Access Compliance Report

Public Rights-of-Way

(Curb Ramps)

Intersection ID: N/A	Main Street: NATIONS_FORD_RD	Cross Street: N/A	Location: W
ADA ID: 6B3F89597EA5	Ramp Type: PerpDiag	Initial Pass/Fail: Fail	Overall Compliance: No
Codes/Mitigation Info/Possible Solution		Field Measurements/Component Compliance	
Severity Score: 25

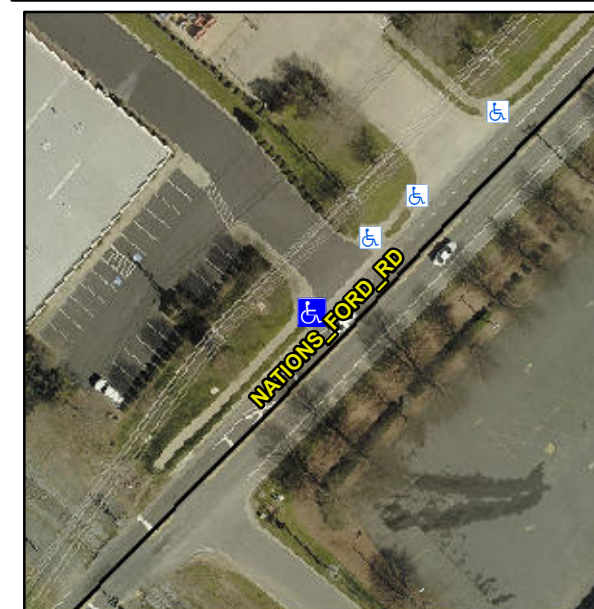
R304.2.2

Compliance	Description	Data	Compliance	Description	Data
N/A	Ramp Length (in)	48.0	No	Ramp Slope (%)	13.3
Yes	Ramp Width (in)	48.0	Yes	Ramp XSlope (%)	1.9
N/A	Flare Type LT	N/A	N/A	Flare Type RT	N/A
N/A	Flare Slope LT (%)	N/A	N/A	Flare Slope RT (%)	N/A
N/A	Flare Traversable LT?	No	N/A	Flare Traversable RT?	No
N/A	Landing Length (in)	N/A	N/A	DWS Provided?	N/A
N/A	Landing Width (in)	N/A	N/A	DWS Contrast?	N/A
N/A	Landing Slope (%)	N/A	N/A	DWS Length (in)	N/A
N/A	Landing X Slope (%)	N/A	N/A	DWS Full Width?	N/A
N/A	Landing Curb? (Y/N)	N/A	N/A	DWS Offset (in)	N/A
N/A	Shared Landing?	N/A			
N/A	Gutter Ponding?	N/A	N/A	Gutter Slope (%)	N/A
N/A	Gutter Lip Ht (in)	N/A	N/A	Gutter X Slope (%)	N/A
N/A	Painted X Walk1?	No	N/A	Painted X Walk2?	No
	X Walk 1 Direction	To SE		X Walk 2 Direction	To NE
N/A	X Walk 1 Width (in)	N/A	N/A	X Walk 2 Width (in)	N/A
	X Walk 1 Slope (%)	2.5		X Walk 2 Slope (%)	1.2
	X Walk 1 X Slope (%)	1.6		X Walk 2 X Slope (%)	7.2

Remove & Replace Curb Ramp With Two New Directional Ramps or Equivalent.
